SERVICE BULLETIN

Service Bulletin No. 077

Alternator Nameplate Inspection

Figure 1 - **CORRECT** Voltage Rating

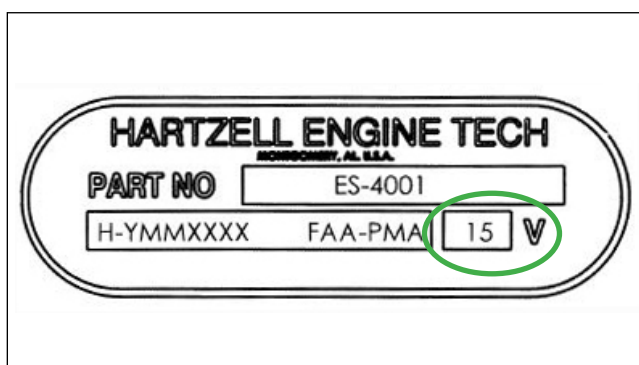
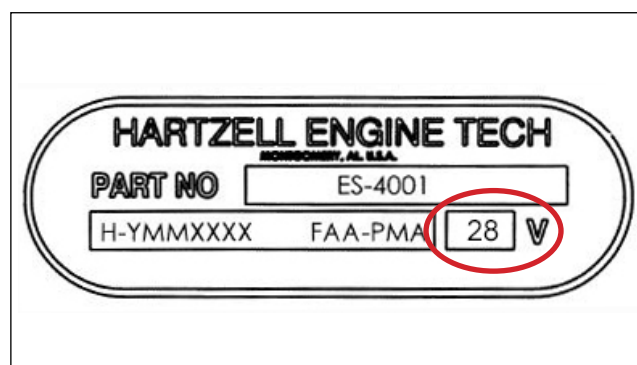
- (1) HET has discovered alternators listed in section 1.A of this SB were shipped with an improper voltage rating displayed on the nameplate.
- (2) The nameplate displays an incorrect rating of 28v. The correct rating should read 15v.
- (3) Operating an affected alternator at 28v could lead to failure of the alternator.

- (1) If previous compliance cannot be verified through aircraft or engine maintenance records, use the same references to determine if an affected alternator has been installed. Refer to section 1.A, Effectivity.
- (2) If effectivity of the alternator cannot be established using aircraft or engine maintenance records, utilize the applicable aircraft maintenance manual to gain access to the alternator and inspect the alternator serial number against affected serial numbers found in section 1.A of this SB.
- (3) If the alternator serial number is affected per section 1.A, inspect alternator nameplate for correct voltage rating. Refer to Figures 1 and 2.
 - (a) If **INCORRECT** voltage rating is observed, continue to 3.B, Corrective Action.

NOTE: Incorrect voltage rating is defined as any voltage found on the nameplate of an affected alternator other than 15v.

- (1) Using a non-metallic scraper, remove the nameplate from the affected alternator.
- (2) Clean alternator housing with denatured alcohol prior to installing the new nameplate.
- (3) Install self-adhesive nameplate P/N 50466 containing the correct voltage rating.
